FAA APPROVED
SUPPLEMENTAL AIRPLANE FLIGHT MANUAL #1
CESSNA MODELS U206F, U206G, TU206F, TU206G

This manual provides information pertaining to the operation of the aircraft when Flint Aero wing tip transfer fuel tanks are installed in accordance with STC SA4366WE.

Revision B

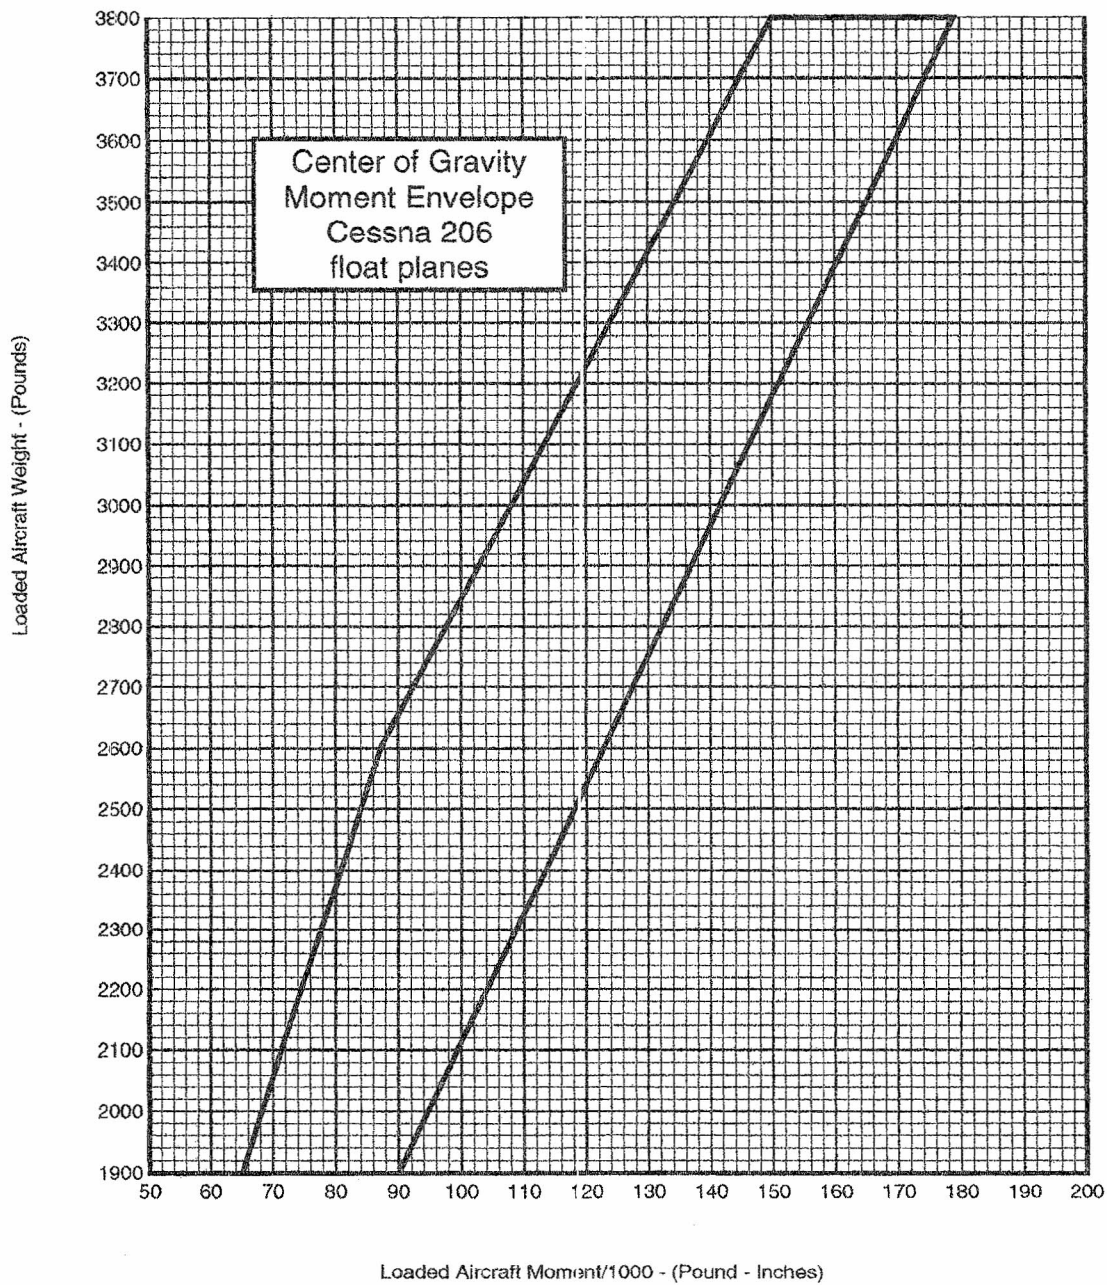
gross weight increased to 3800 lbs.

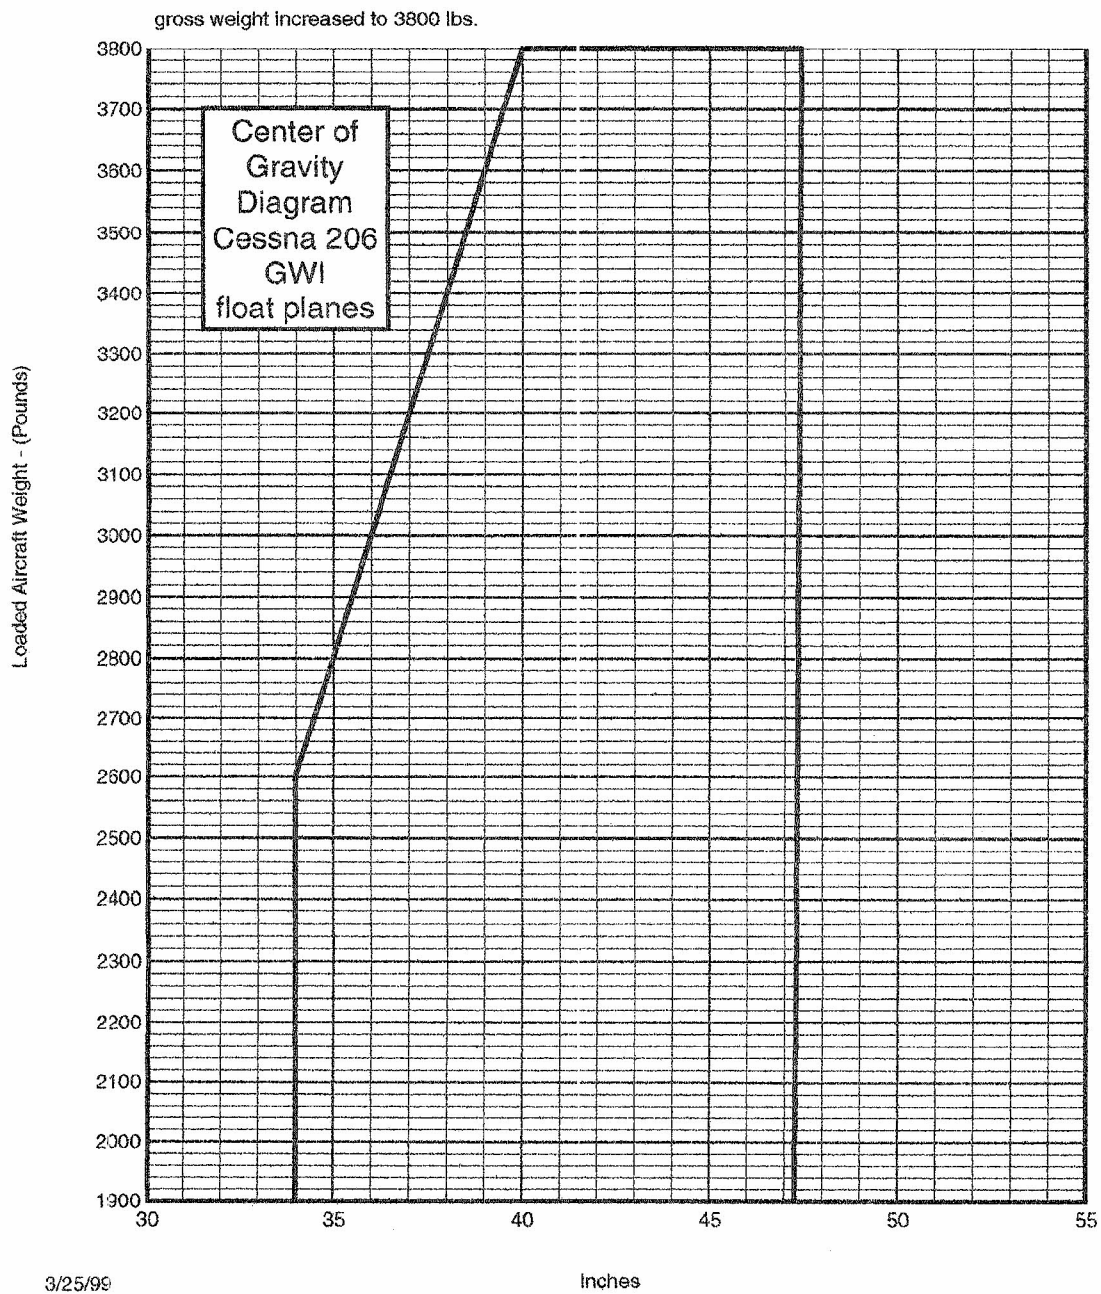
gross weight increased to 3800 lbs.

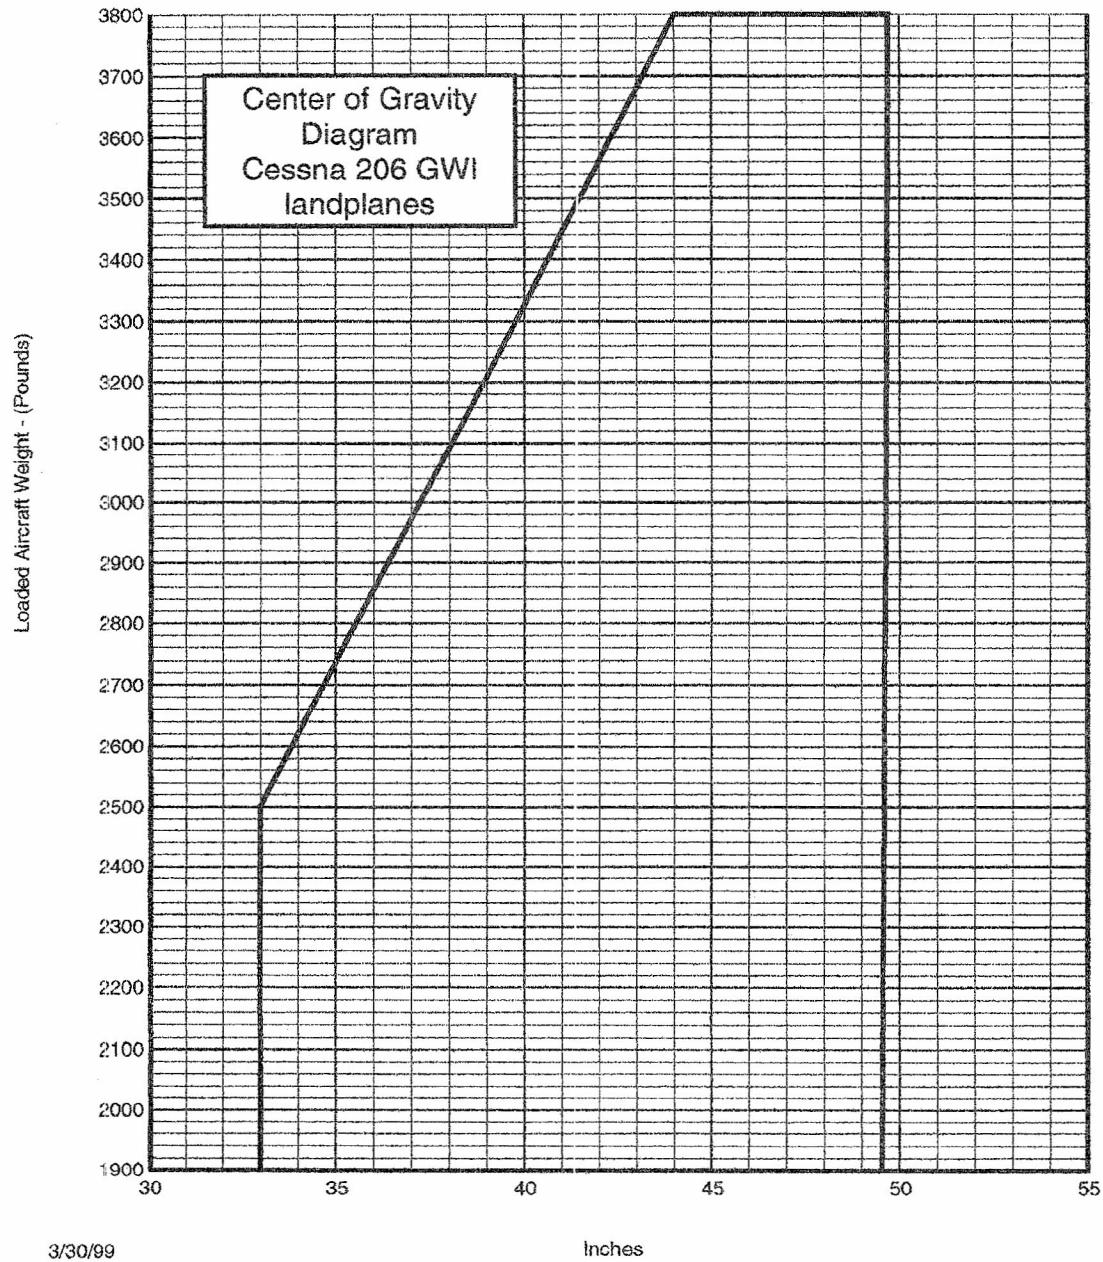
gross weight increased to 3800 lbs.
